11th CSPCWG-1st NCWG MEETING
Rostock, Germany 27-30 April 2015

Paper for Consideration by NCWG
Refuge Anchorage/Area

Submitted by:	UK
Executive Summary:	Italy established a 'refuge area' in Port of Augusta – how should this be charted?
Related Documents:	S-4; INT1
Related Projects:	None

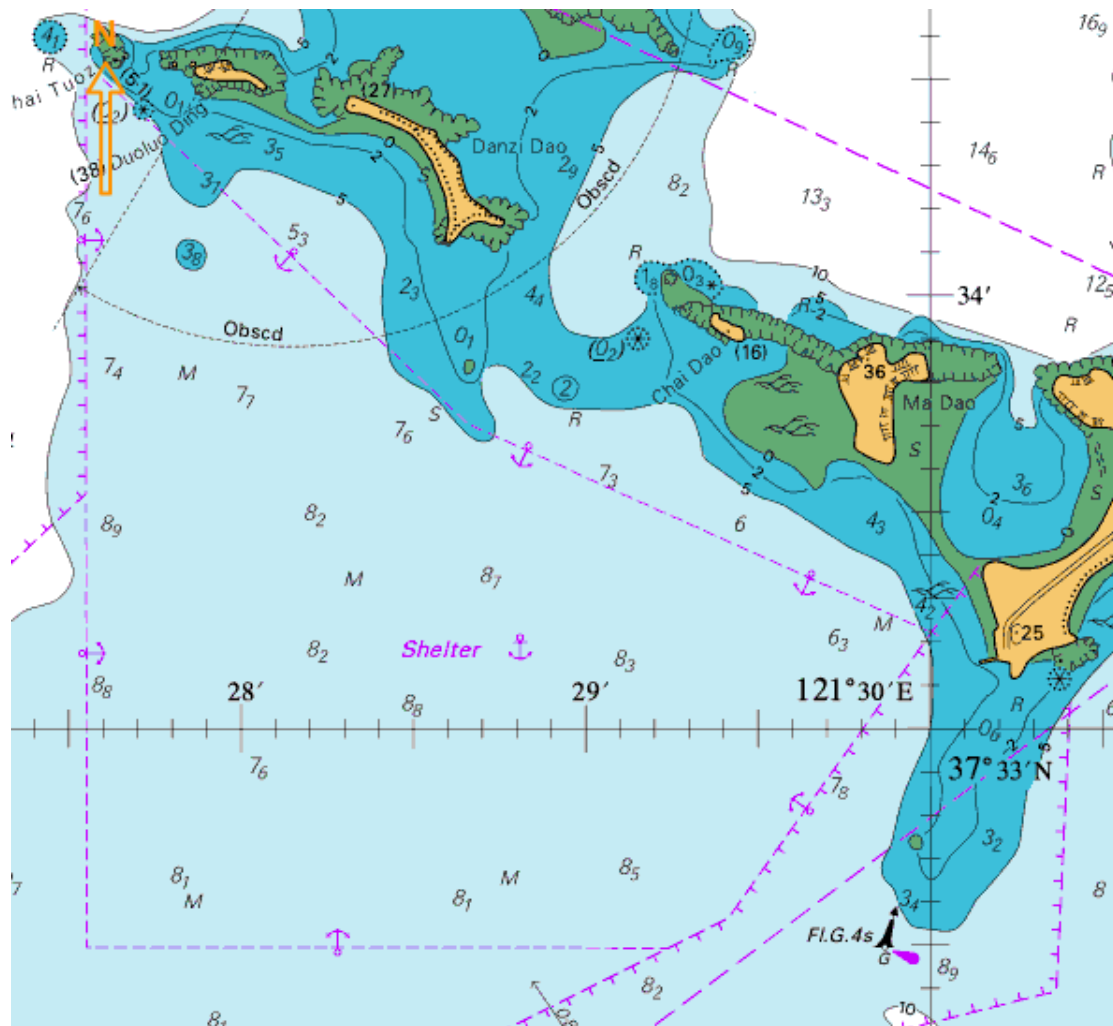
UKHO chose to include this on the relevant chart as:

In the case of the Italian NM, the word 'refuge' is used. An assumption is made that the area is an anchorage (because of the reference to the muddy seabed), so the area has been shown as an anchorage using N12.1-9 adapted as a Refuge anchorage by using the international abbreviation 'Ref' alongside the anchor (the addition of the full stop is an error).

If the area was simply a refuge area, rather than an anchorage, then the limit would be N1.2, with a sloping, magenta 'Ref' inside (possibly in full as 'Refuge Area' if the extent of the area is large).

Refuge areas and/or anchorages should be indicated by the existing agreed international abbreviation 'Ref', adapted for association with a maritime area (therefore magenta, sloping text).
